V2500-D5 SERIES NACELLE SERVICE BULLETIN

This document transmits Revision 1 to Service Bulletin NV2500-78-0196

V2500-NAC-78-0196

COMMON NOZZLE ASSEMBLY (CNA) – OUTER BARREL – MODIFICATION TO PREVENT ELONGATION OF
UPPER AND LOWER STRUT ATTACH HOLES

CNA - Strut Skin and Outer Fitting Modification
Figure 1 (sheet 1)

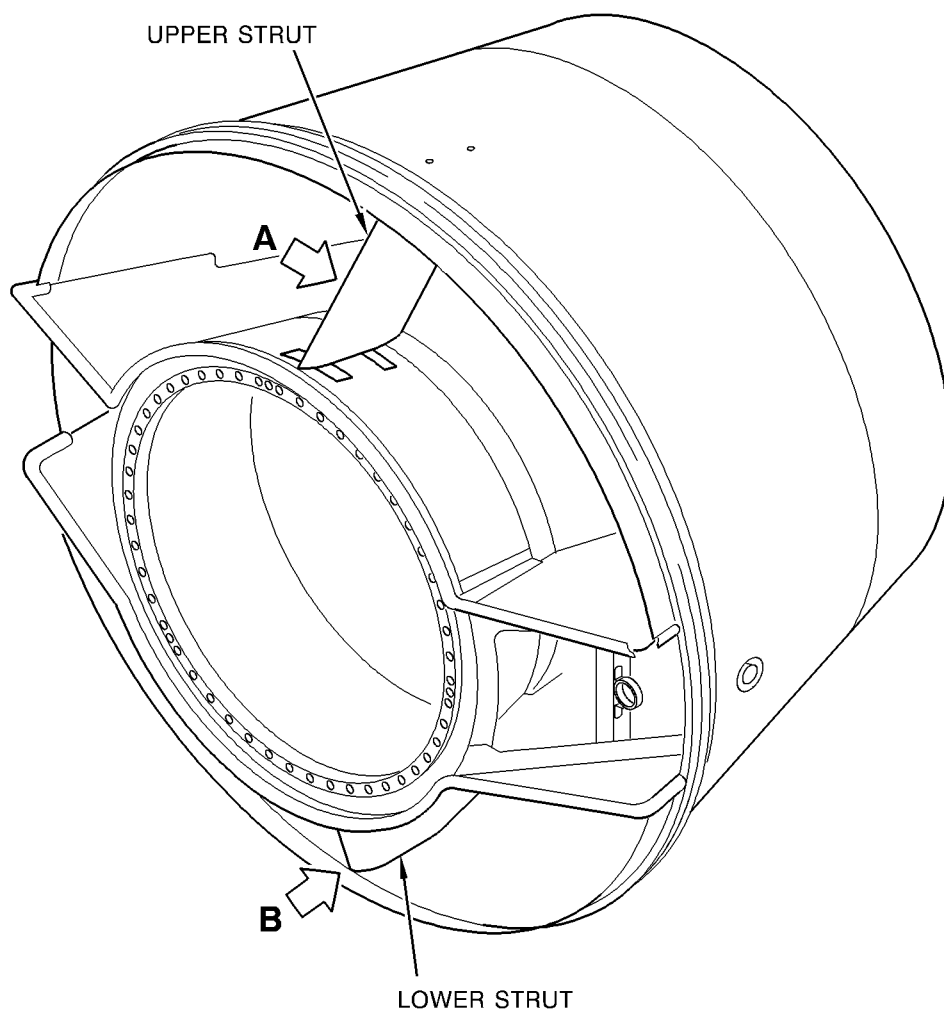
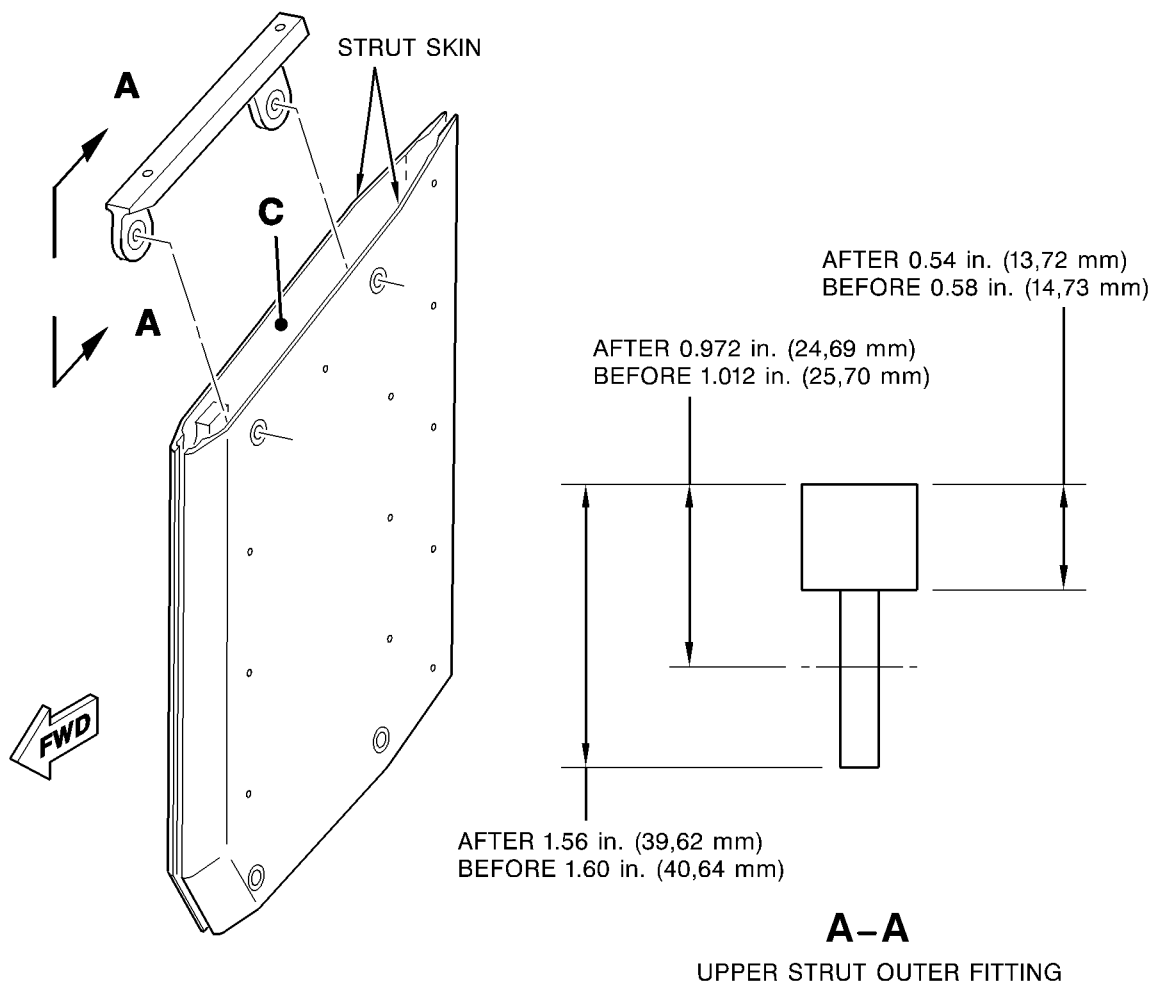
- (1) Clean the strut skins with a lint free cloth (CoMat 02-099) made moist with solvent (CoMat 01-438). Wipe the surfaces dry before the surfaces become dry.
- (2) Remove material from the strut skins. Refer to Figure 1.
- (3) Clean the modified areas with a lint free cloth (CoMat 02-099) made moist with solvent (CoMat 01-438). Wipe the surfaces clean and dry before the solvent becomes dry.

CNA - Strut Skin and Outer Fitting Modification
Figure 1 (sheet 2)

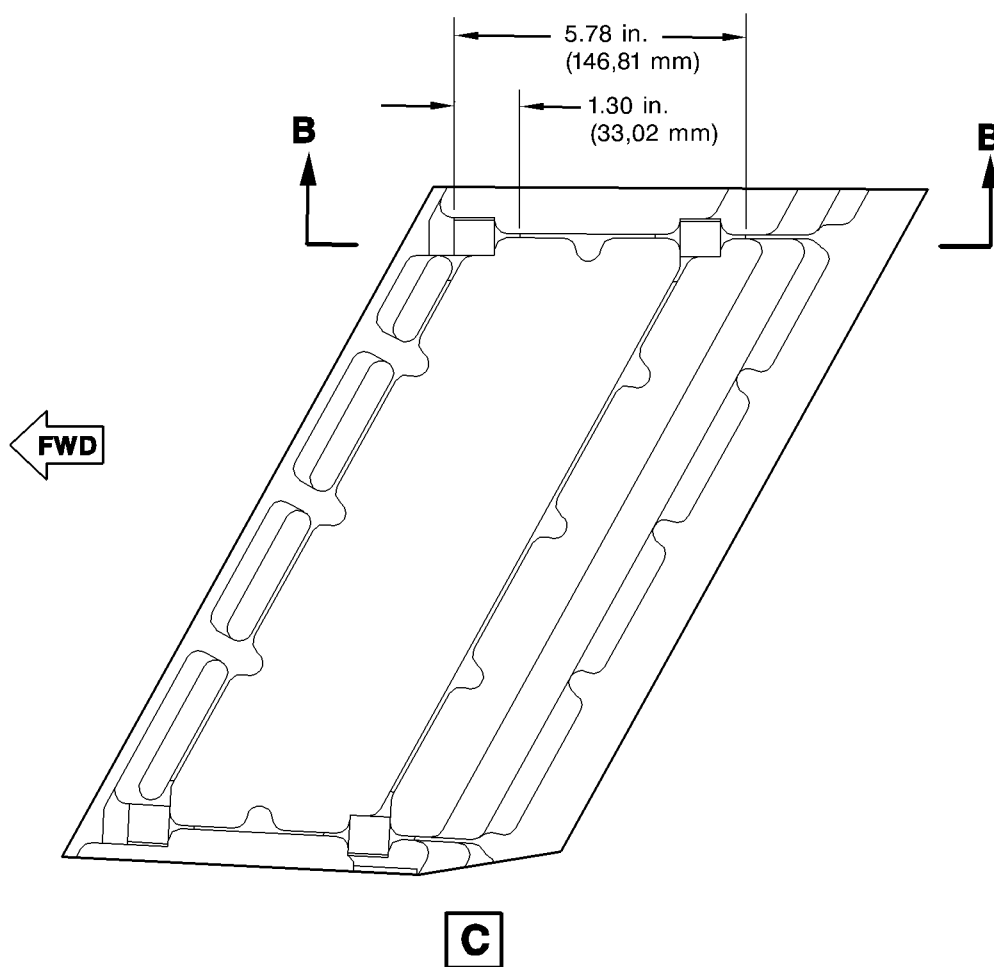
BEFORE MODIFICATION
(Typical both skins)

B-B
BEFORE MODIFICATION

CNA - Strut Skin and Outer Fitting Modification
Figure 1 (sheet 3)

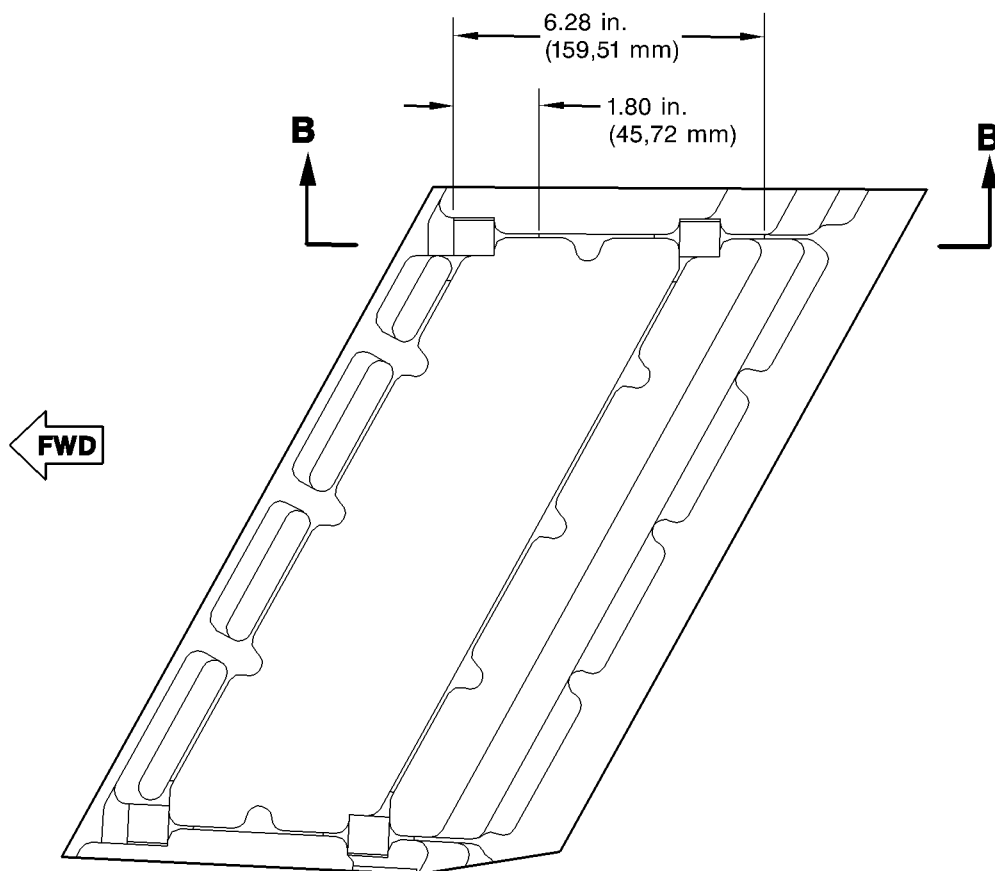
AFTER MODIFICATION
(Typical both skins)

B-B

AFTER MODIFICATION

CNA - Strut Skin and Outer Fitting Modification
Figure 1 (sheet 4)

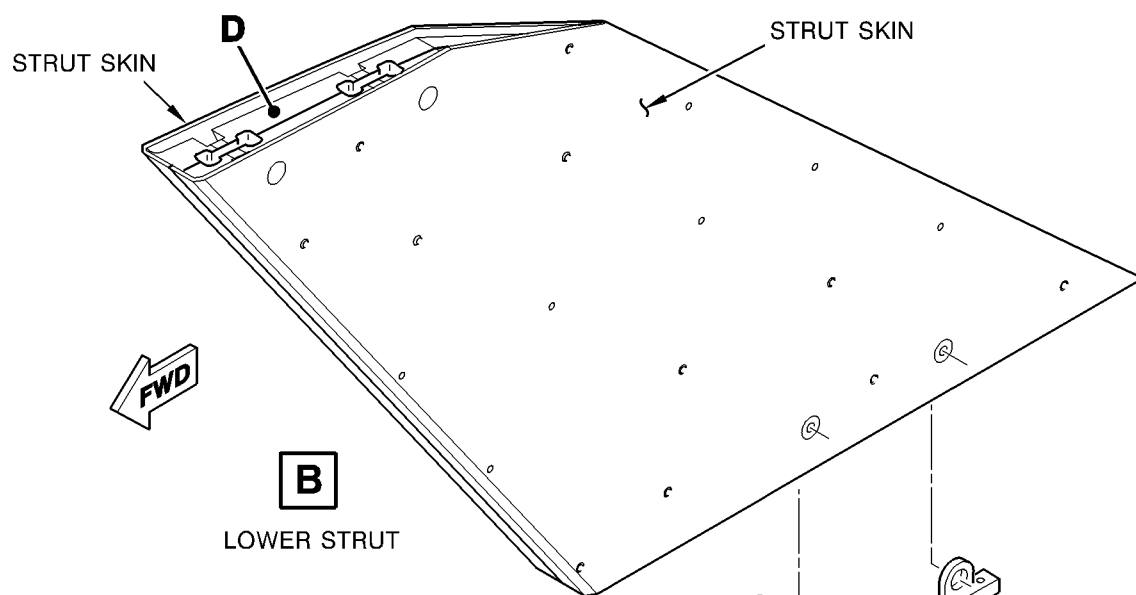
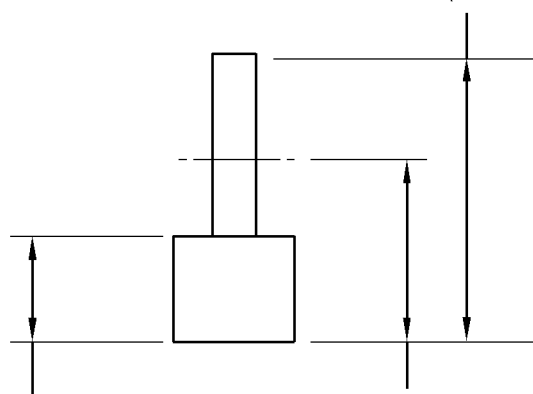
AFTER 1.56 in. (39,62 mm)
BEFORE 1.60 in. (40,64 mm)

AFTER 0.54 in. (13,72 mm)
BEFORE 0.58 in. (14,73 mm)

AFTER 0.972 in. (24,69 mm)
BEFORE 1.012 in. (25,70 mm)

LOWER STRUT OUTER FITTING

- (1) Clean the outer fittings with a lint free cloth (CoMat 02-099) and solvent (CoMat 01-438).
- (2) Remove material from the surface of the fittings that mates with the inner surface of the outer barrel. Refer to Figure 2.
- (3) Remove the sharp edges from the fittings.
- (4) Clean the outer fittings with a lint free cloth (CoMat 02-099) solvent (CoMat 01-438). Wipe the surfaces clean and dry before the solvent becomes dry.

CNA - Strut Skin and Outer Fitting Modification
Figure 1 (sheet 5)

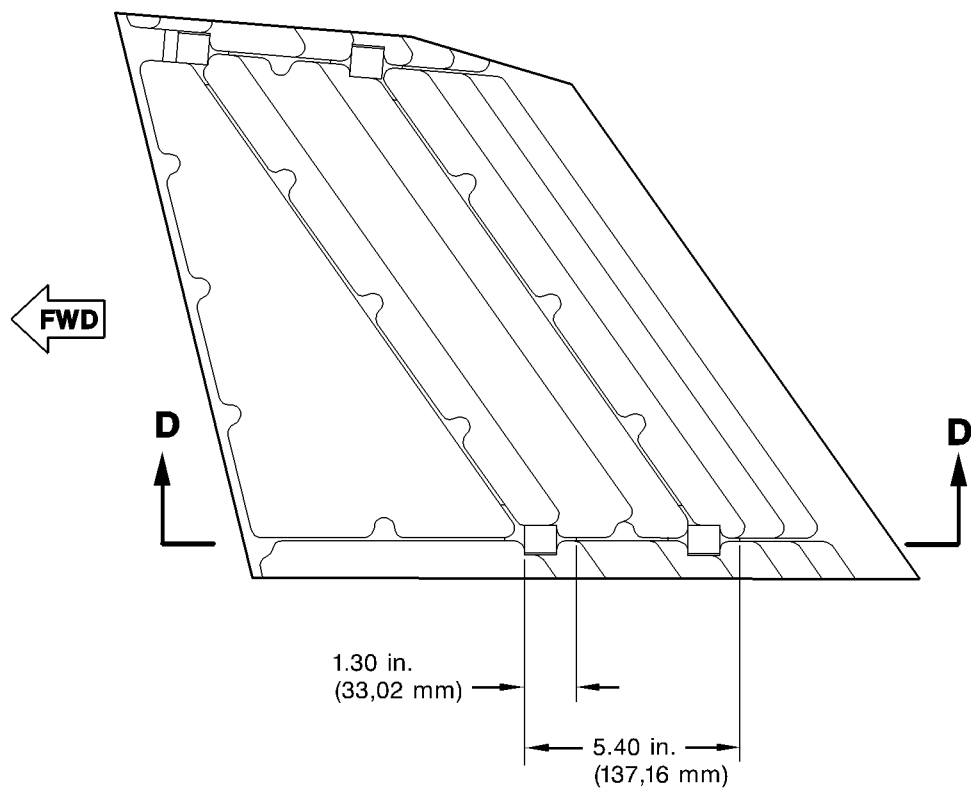
BEFORE MODIFICATION
(Typical both sides)

D-D

BEFORE MODIFICATION

CNA - Strut Skin and Outer Fitting Modification
Figure 1 (sheet 6)

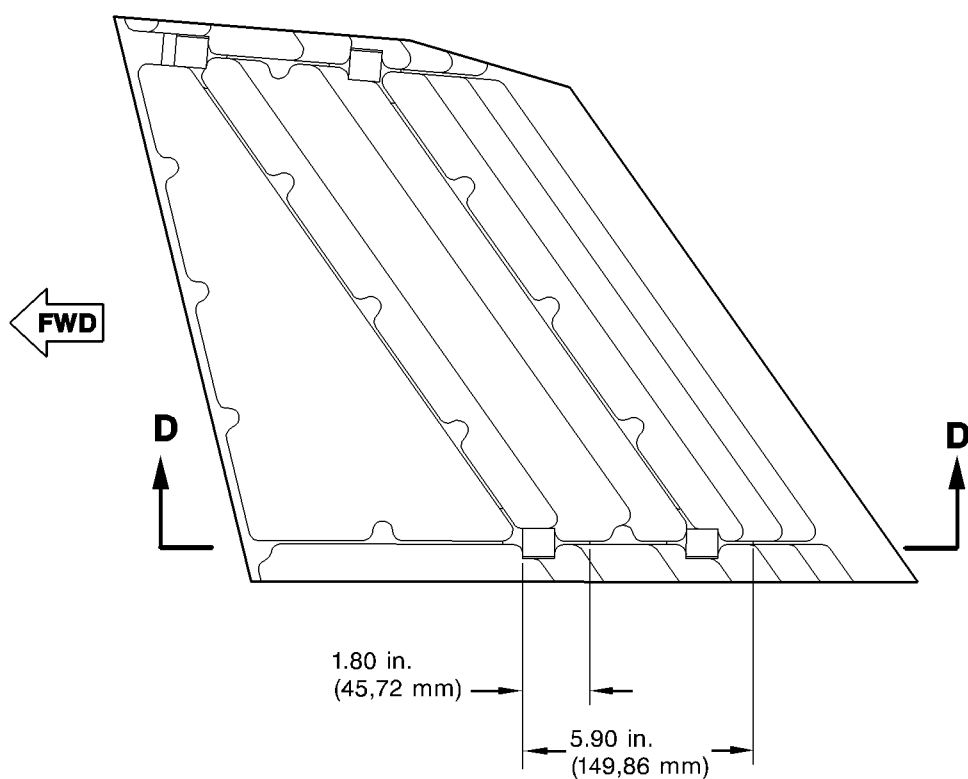
AFTER MODIFICATION
(Typical both sides)

D-D

AFTER MODIFICATION

Make the Doublers and Laminated Shims
Figure 2

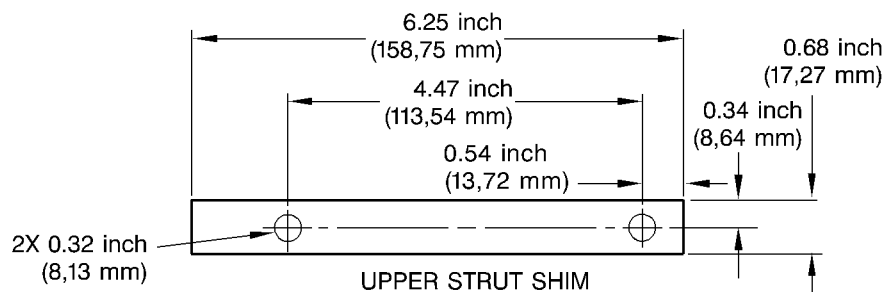
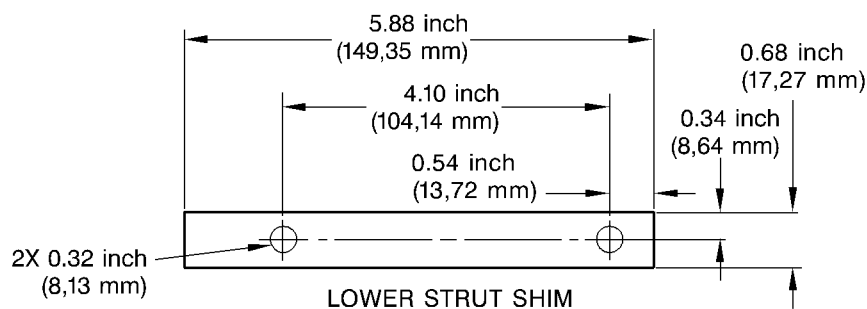
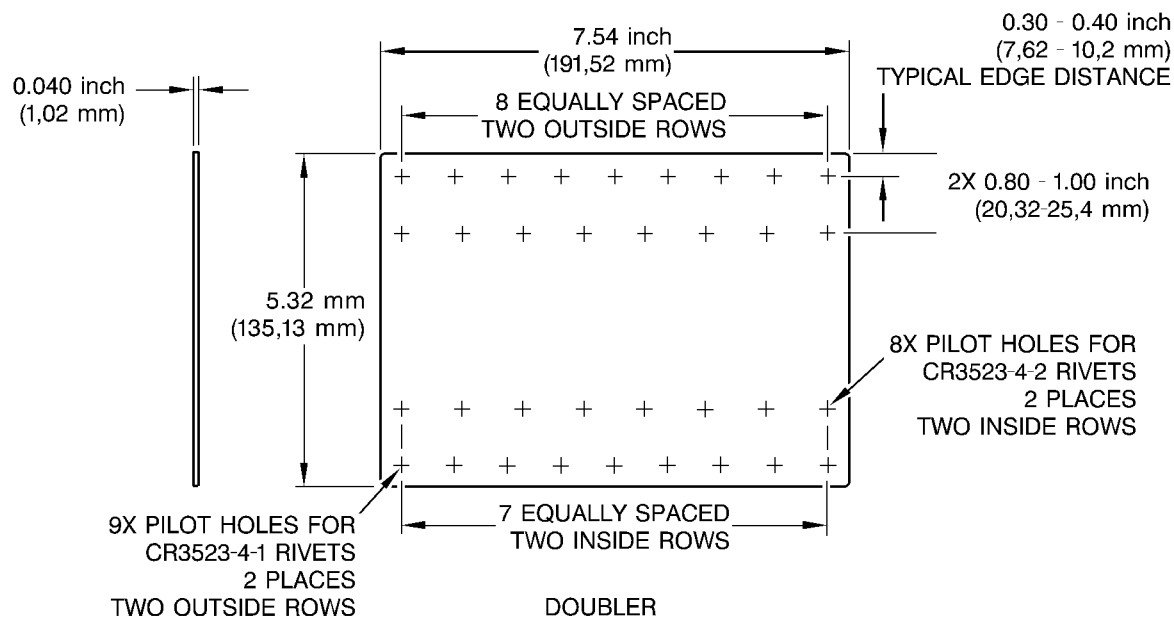
- (1) Make the doublers from MIL-S-5059, Type 301, 1/2 Hard Cres sheet. Refer to Figure 2.

- (1) Make the laminated shims from MIL-S-22499, Composition 1, Type 1, Class 1 Laminated CRES. Refer to Figure 2.

NOTE: Repair 006 instructs forty eight (48) CR3523-4-1 and twenty two (22) CR3523-4-2 rivets to install each doubler. You will use eighteen (18) CR3523-4-1 and sixteen (16) CR3523-4-2 rivets when you install each doubler as shown in Figure 2 of this bulletin.
